MEMORANDUM

FROM: Gregory M. Sommer, P.E., Assistant Town Engineer

RE: 204 Fern Street (Elizabeth Park Pedestrian Walkway)
Special Use Permit Application No. 1343

DATE: August 28, 2019

CONCRETE RAMP CROSS SECTION

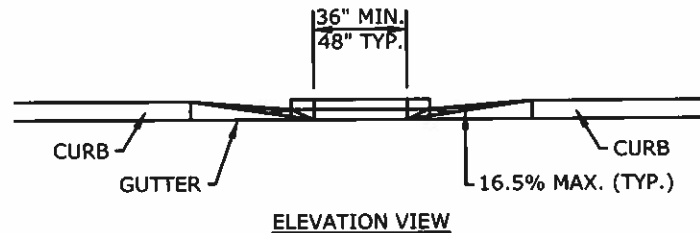
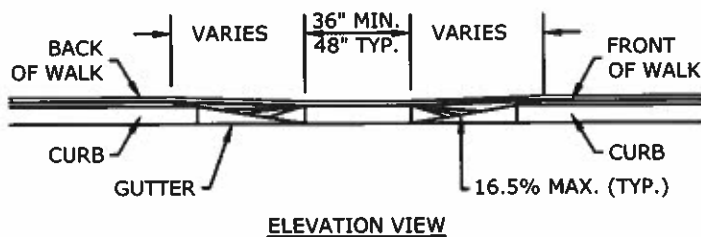
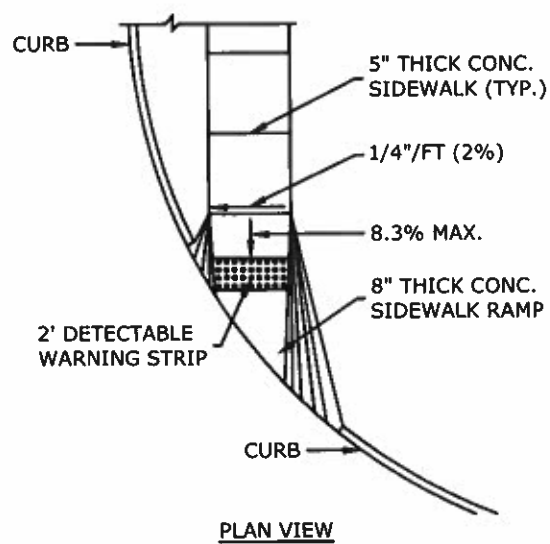
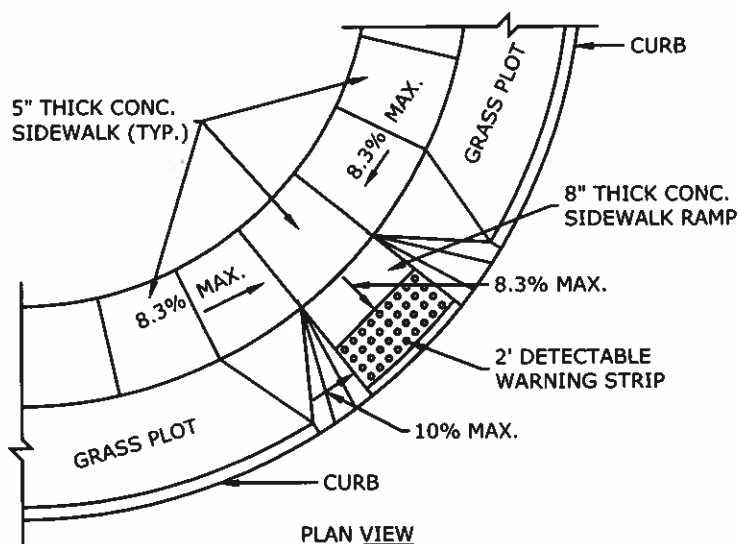
2. Install a sidewalk/curb ramp on the south side of Fern Street, opposite the proposed walkway to provide accessible access.
3. Sidewalk/curb ramps shall be constructed with class 'F' concrete, 8" thick, with #8 wire mesh. See attached detail.

4. Sidewalk/curb ramps are preferred to have sloped concrete wing sections with concrete curb transitions rather than granite curb edging. The 90 degree corner formed by the granite could present challenges during winter snow clearing operations.

- *Added information to revised detail #2/L-5.0.*
4. Sidewalk/curb ramps are preferred to have sloped concrete wing sections with concrete curb transitions rather than granite curb edging. The 90 degree corner formed by the granite could present challenges during winter snow clearing operations.

- *Revised detail, see detail #2/L-5.0.*
5. Pedestrian crossing signs (MUTCD W11-2) with supplemental downward arrows (MUTCD-W16-7P) shall be installed at the proposed crosswalk on both sides of Fern Street. Advance warning signs (MUTCD W11-2) with supplemental 'Head' plaques (MUTCD W-16-9P) shall also be installed approximately 200-250 feet in advance of the proposed crosswalk. The recommended placement of advanced warning signs for westbound traffic is near utility pole #5858 just east of #190 Fern Street and near utility pole #2971 at #211 Fern Street for eastbound traffic. All signs shall be yellow, NOT florescent yellow green. Coordinate with West Hartford Engineering Division if there are any questions regarding sign placement.
